ADDENDUM NO. 2

PETALUMA TURNING BASIN FLOAT, PILE, AND GANGWAY REPLACEMENT City Project Number C14402010

July 20, 2023

SHEET
S-301
 9 OF 12

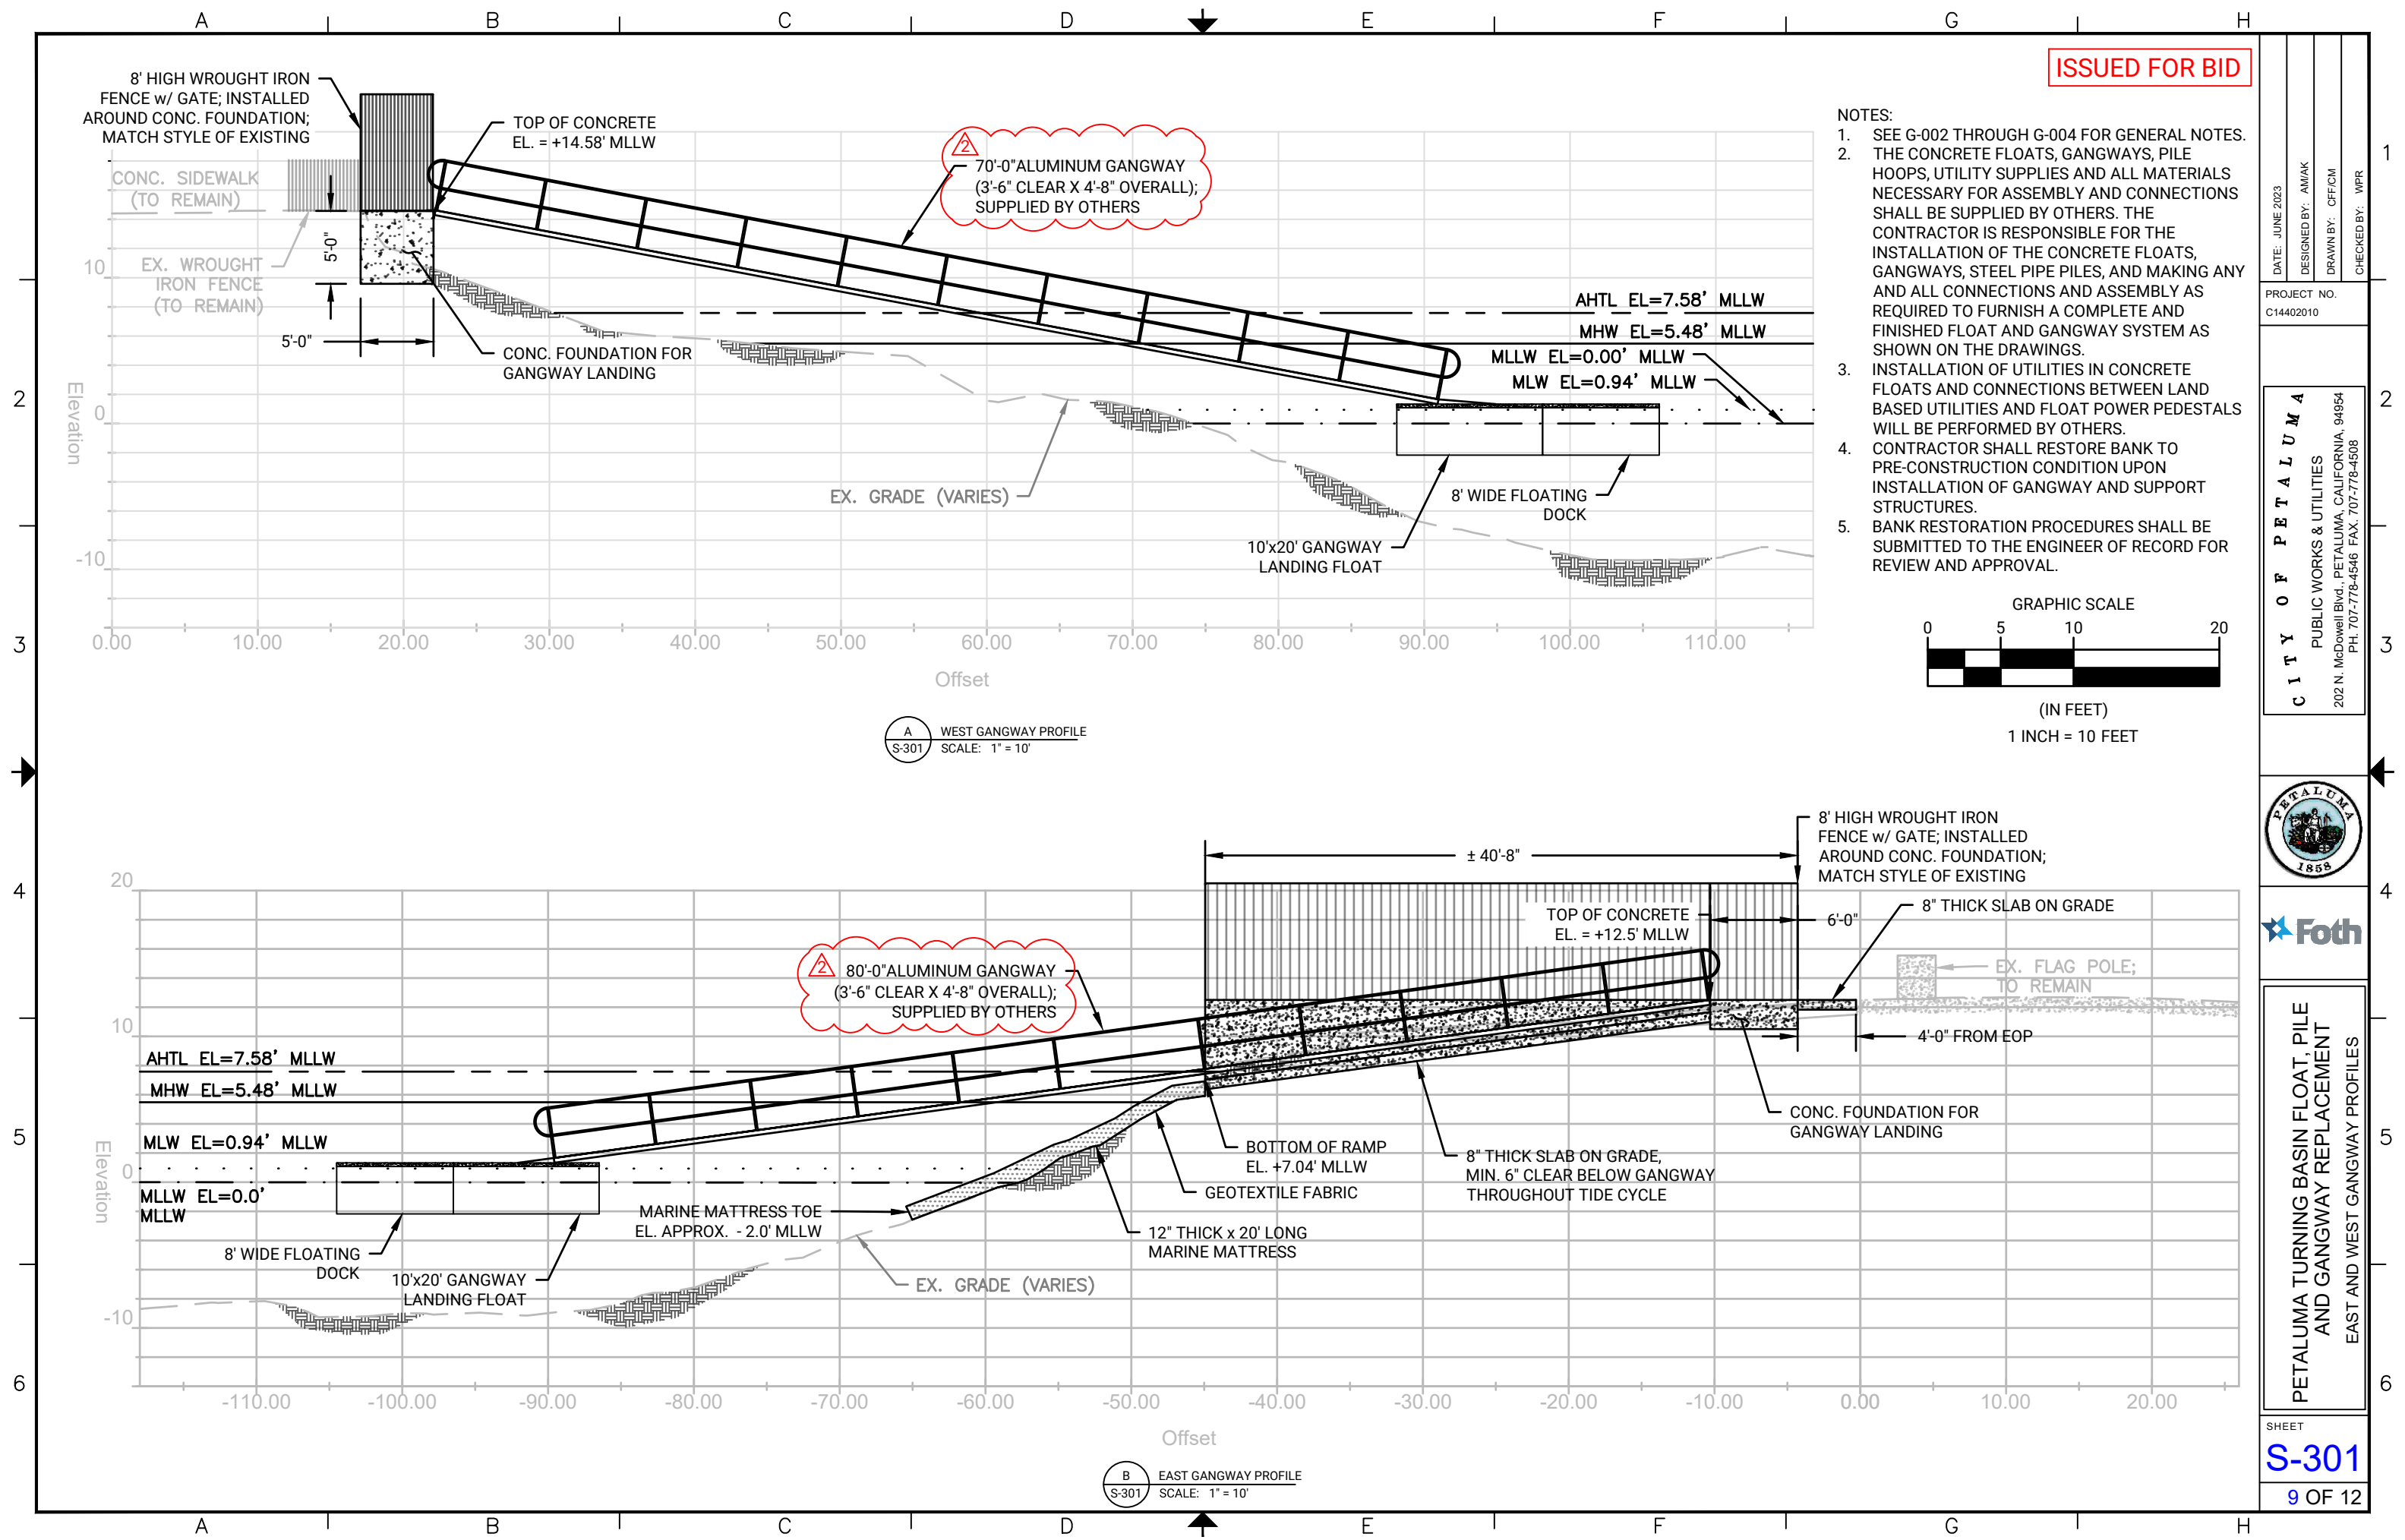
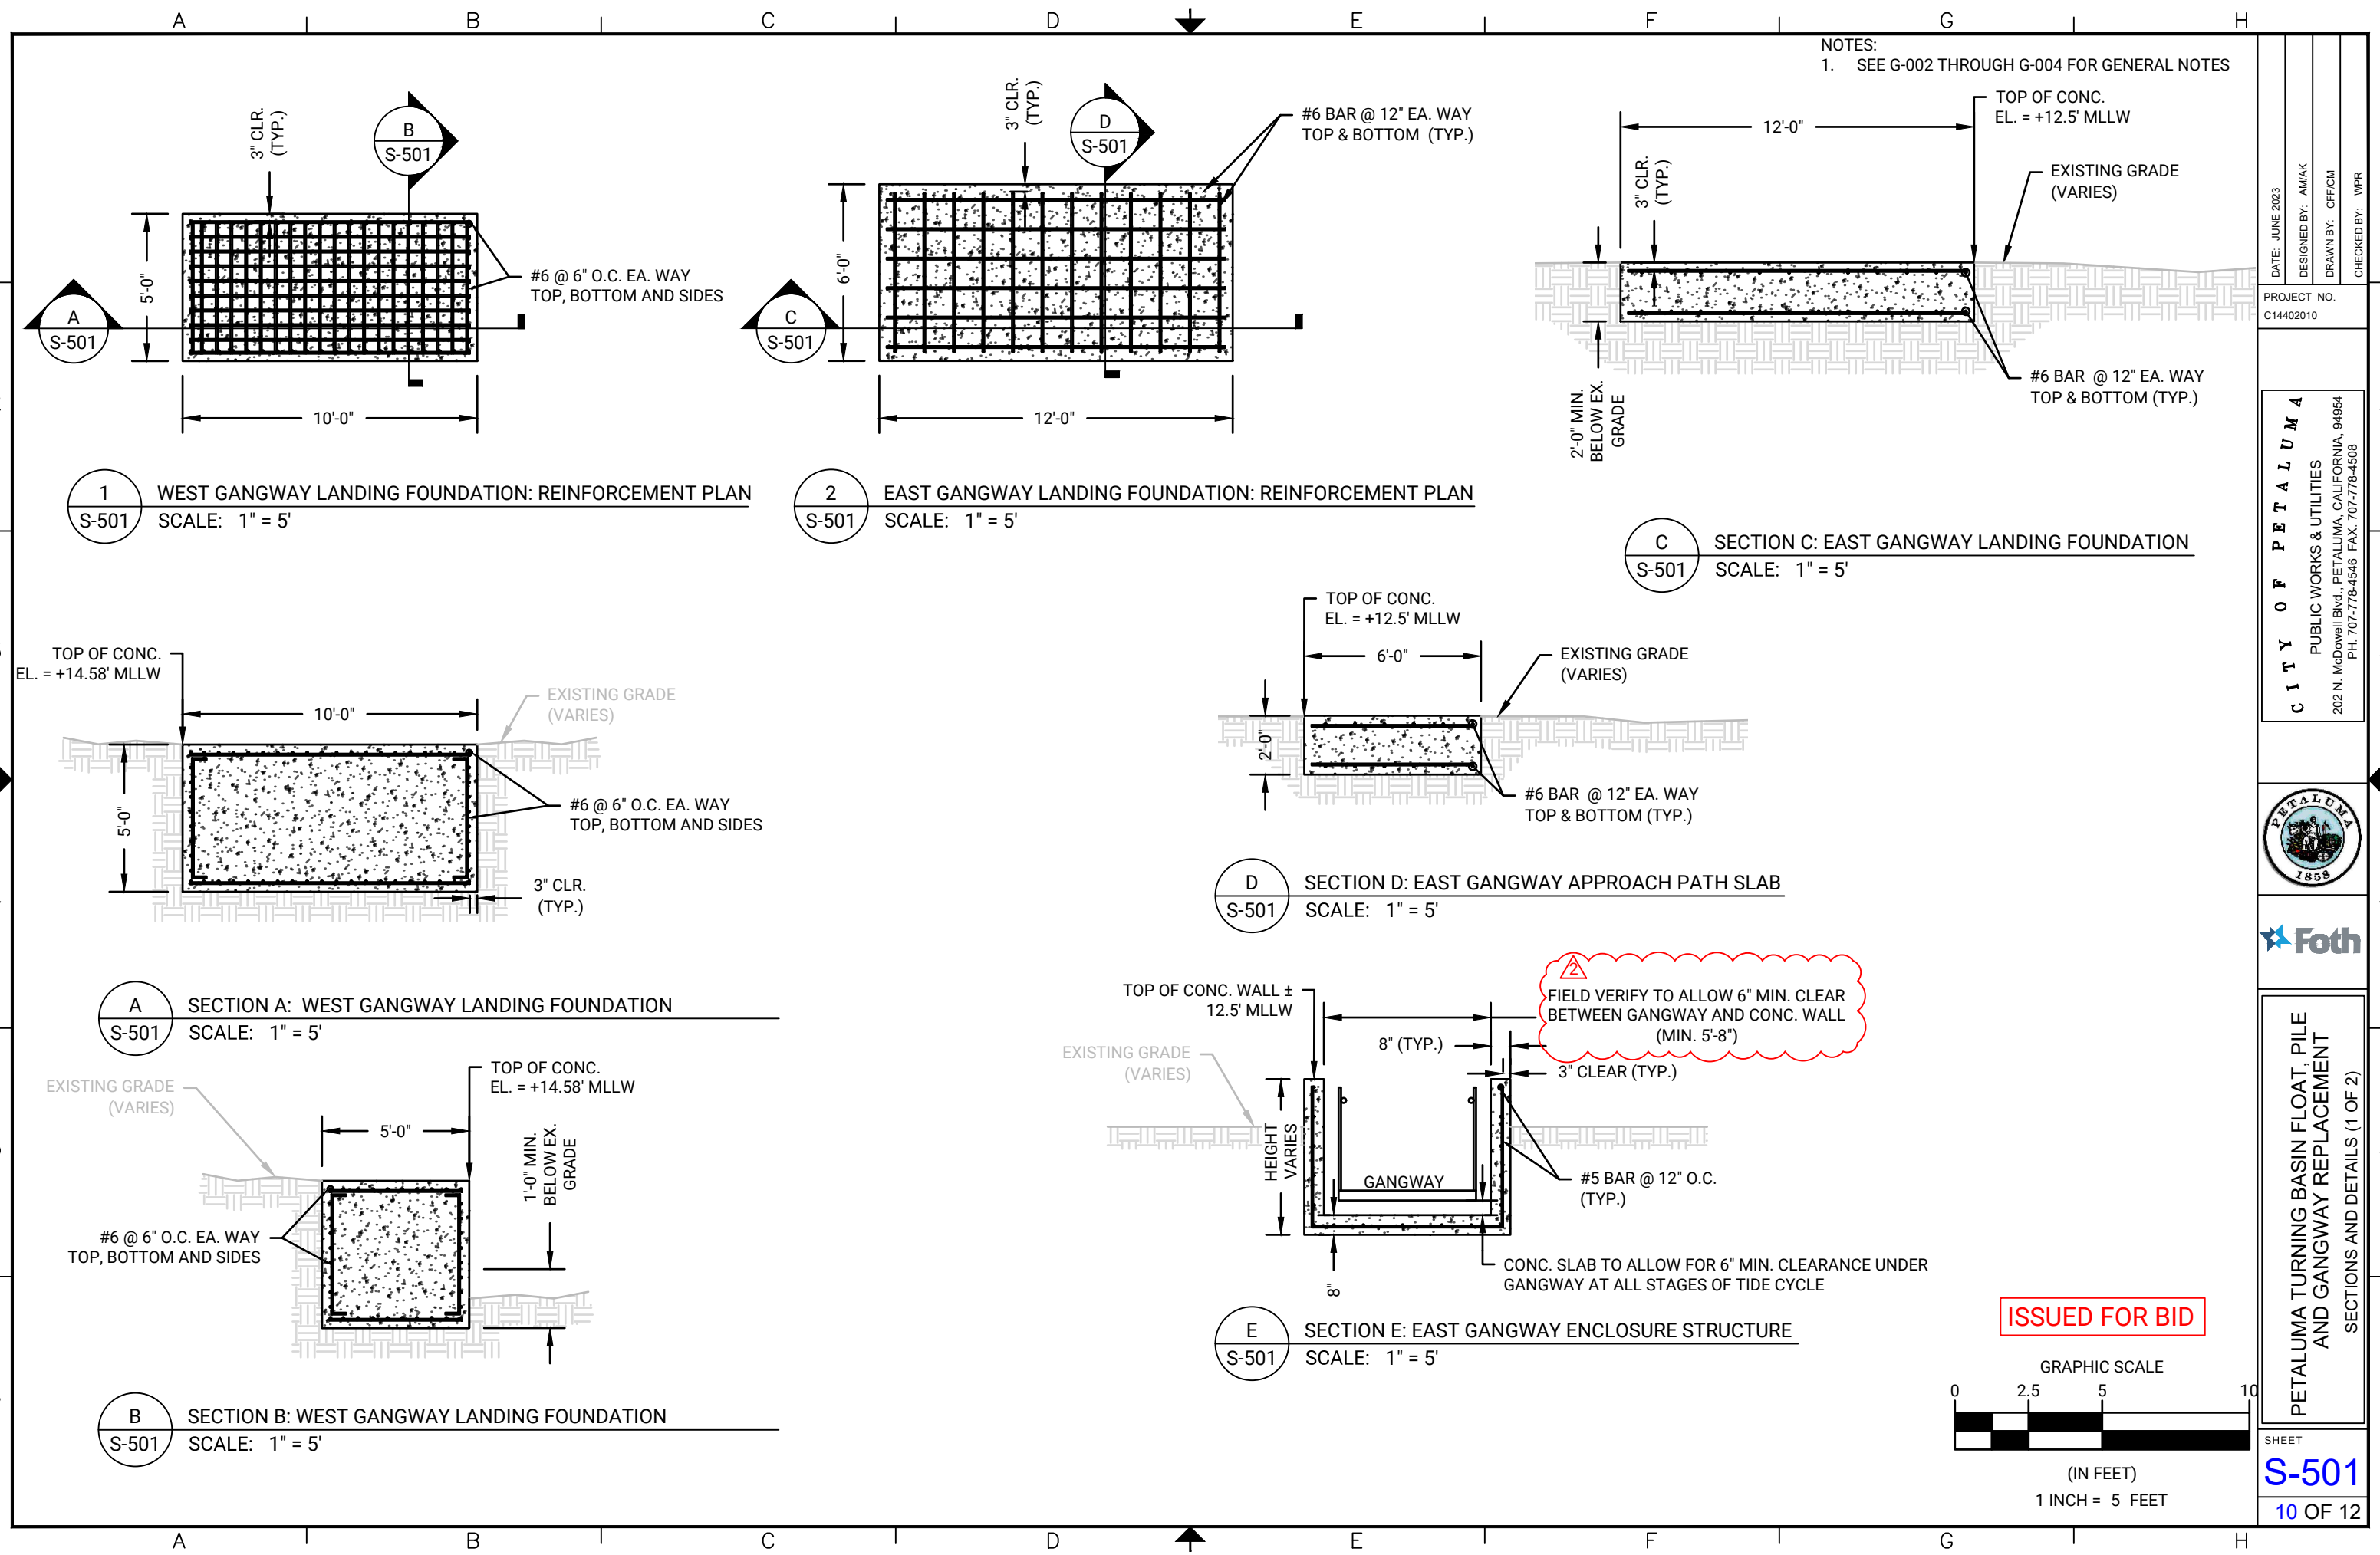
Q19: *Sheet S-301, Detail B, East Gangway The plans show a 6" clearance from the bottom of the gangway to the 8" concrete slab based on a MLLW Level. We respectfully don't believe this will work since the water level goes below MLLW and would hit the slab on a lowest observed low water level. Please advise.*

A19: Foth has reviewed this condition and ensured that the clearance as designed is adequate.

3 DOCK MOUNTED SOLAR MARINE LIGHTS
S-502 SCALE: NOT TO SCALE

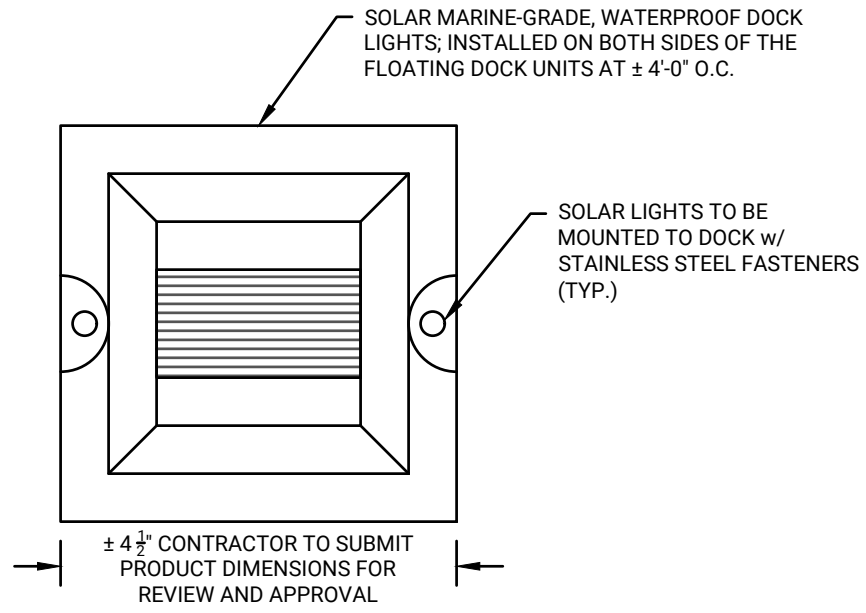
Q11: *The plans and specification call for a “Solar Marine Grade Waterproof Dock Light”. Can the city specify the exact light to bid? It is our experience that these types of lights do not last more than 1-year and we highly recommend that these be removed from the bid.*

A11: Solar Marine Grade Waterproof Dock Lights shall be in accordance with the requirements of Section VI, Project Plans, Sheet G-003 “Notes, Abbreviations, and Symbols (2 of 3)” and Sheet S-502 Detail 3. An acceptable product is the *Taylorbrite Marine Grade Solar Deck Lite* made by Taylor Made or equal as approved by the Engineer.

4 TYPICAL MARINE MATTRESS DETAIL
S-502 SCALE: NOT TO SCALE

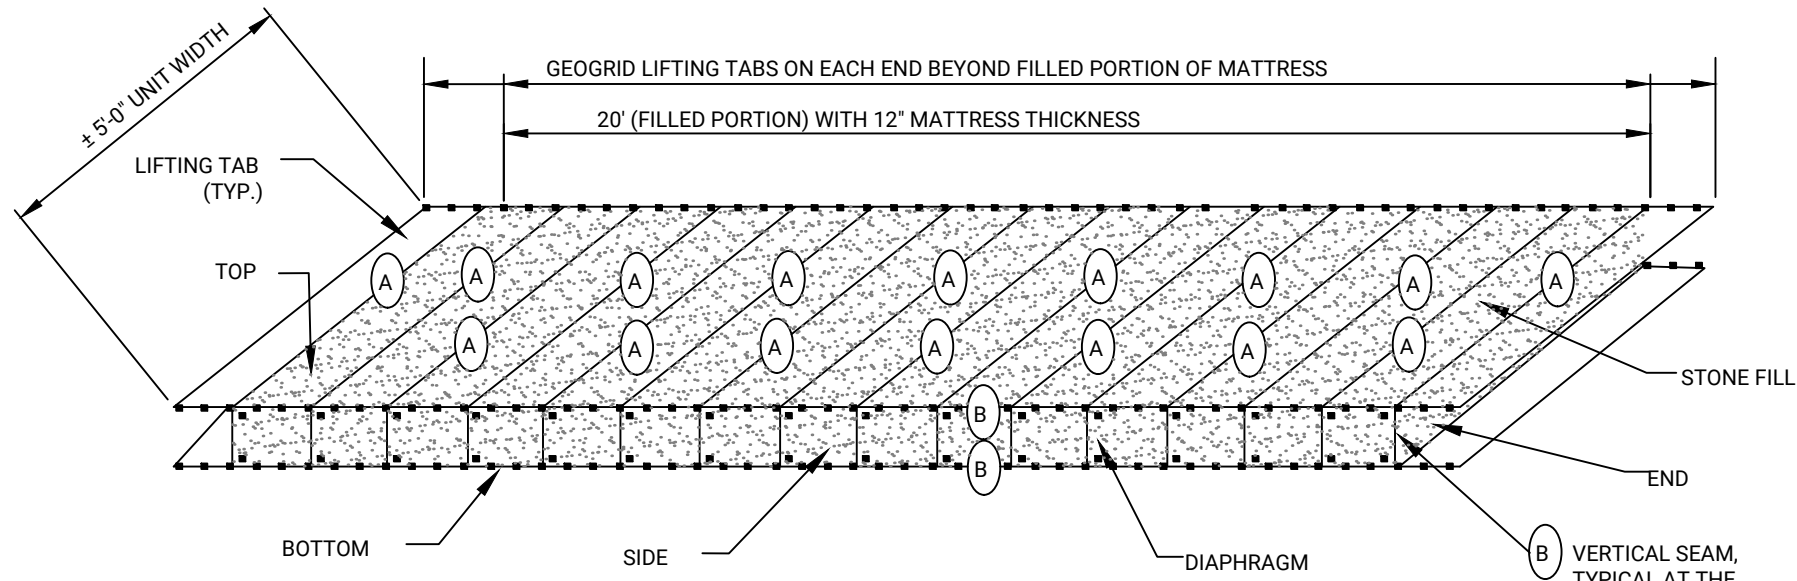
Q22: *Per plans sheet S-502 detail 4, marine mattress detail shows the marine mattress at 5' wide and Sheet S-101 shows the marine mattress at 15' wide. Can the city please clarify how wide the marine mattress is?*

A22: The marine mattress should cover a 15' wide area as shown in S-101. Sheet S-502, shows a 'typical detail' for a marine mattress unit (one unit) of 5' wide +/-, meaning that, three (3) units will be laid side by side. The Contractor shall submit their proposed marine mattress product and layout plan to the Engineer for review and approval.
